MINUTES OF THE REGULAR MEETING OF THE PLAN COMMISSION, VILLAGE OF TINLEY PARK, COOK AND WILL COUNTIES, ILLINOIS

ITEM #1: PUBLIC HEARING – CHIPOTLE NEW CONSTRUCTION, 7121 159th

PLAN COMMISSION STAFF REPORT

Chipotle Outlot New Construction

Proposed Plat of Subdivision (3 Lots): "Tinley Park Shopping Center", Sheet 1

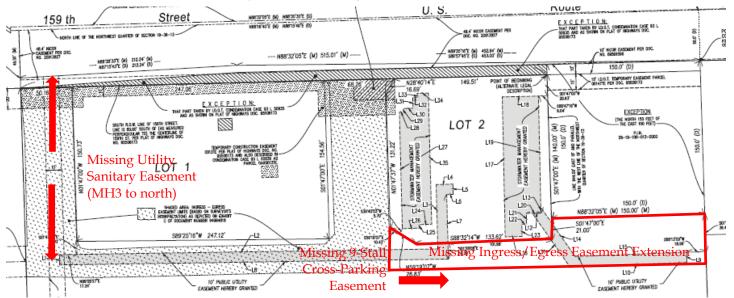
The final plat of subdivision as currently submitted includes existing easements as well as proposed easements for public utilities and stormwater management. However, an extended ingress/egress (access) easement and cross-parking easement are not yet shown on the plat. The Petitioner has noted that in order to provide the minimum required amount of parking as required by code, that nine parking stalls will be located off-site on the Floor & Décor/Hobby Lobby parking lot, south of the future Chipotle outlot. Additionally, the extension of the ingress/egress easement is requested to run south of the Chipotle outlot and the Midas outlot (which is the 150 ft. long plat exception east of the Chipotle outlot) to meet the east

property line. In other words, the ingress/egress easement would extend east of 71st Court (where it currently terminates) to the easternmost edge of the entire development (east property line of proposed Lot 3) to provide access to the other commercial developments east along the block (Menards, etc.).

The Village Engineer has also required that a utility easement be provided between Manhole 3 and the north property line if the development is going to utilize the existing sanitary service to Floor & Decor.

Open Item #2: Review the proposed plat of subdivision. Consider condition of approval to require the nine-stall cross-parking easement which may be included in the Plat of Subdivision or recorded separately at the same time. The Cross-access easement shall be revised to include the entrance and main drive aisle connecting all three lots.

Village staff has not yet received a revised plat of subdivision to note the easements, but will do so prior to the Village Board meeting. At minimum, the cross-access and utility easements are required to be shown on the plat of subdivision. Staff recommends a condition of approval to require the nine-stall cross-parking easement shall be included in the plat of subdivision or recorded separately at the same time. Staff also recommends conditioning that the cross-access easement shall be revised to include the entrance and main drive aisle connecting all three lots.

Revised Site Plan (architectural), rec'd 9/27/22

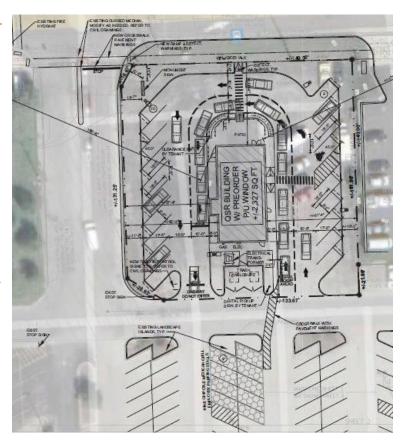
Pedestrian connectivity will be possible via a new sidewalk and crosswalk which is required for this development, and will lead to the main entry on the north side fronting 159th Street. The Village Engineer has provided feedback on requirements. The Geometry Plan on the civil drawings (GSG)

Consultants, Sheet 6) reflect the details so that it is accessible and can connect across 71st Court to the Burger King outlot. These include the cut median, crosswalk, stop bar, and ramp. These improvements were not noted in the

architectural site plan (Soos Associates) and will be required. The Petitioner is waiting for direction from IDOT on whether the sidewalk ramp and crosswalk will be allowed since pedestrian signal heads and push buttons do not exist at this intersection corner. Crosswalk markings per MUTCD standards will also need to be shown.

Open Item #3: Review the overall site plan changes, proposed traffic circulation, and proposed patio addition.

At the Workshop, there was some feedback to consider inclusion of a drive-aisle crosswalk between the outlot and the 9-stalls of off-site parking to the south. The Petitioner has provided revised drawings will be subject to final engineering review which may require adjustment or removal.
